Type H&C - HORECA	Model 9100 – 95 – kalea Plus – Opera Touch	N° T.I. 12 - 2019				
Serial Number 94312015	Subject Z4000 coffee unit strengthen (ES-FB, HoReCa)	ISSUED FOR (X) <table border="1"> <tr> <td>Action</td> <td></td> </tr> <tr> <td>Information</td> <td>X</td> </tr> </table>	Action		Information	X
Action						
Information	X

To strengthen the Z4000 ES-FB coffee unit.

New Pinion code 262496

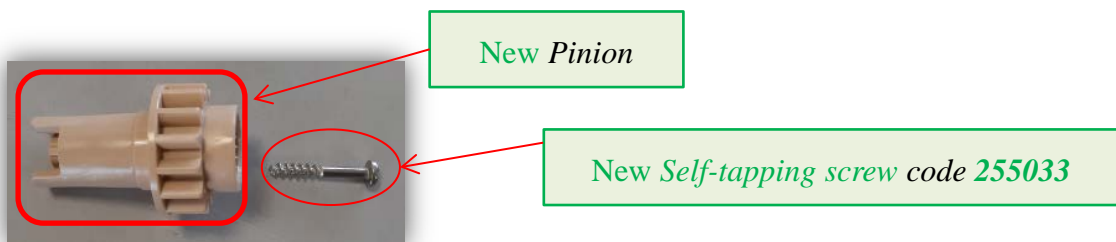
Introduction of a new coffee unit *Pinion* and a *self-tapping screw*.

Old Pinion code 254673

EXCHANGEABILITY:
The modification is retrofittable by ordering the spare code **262497**
 (The retrofit pack does include 2 pinions + the screw).
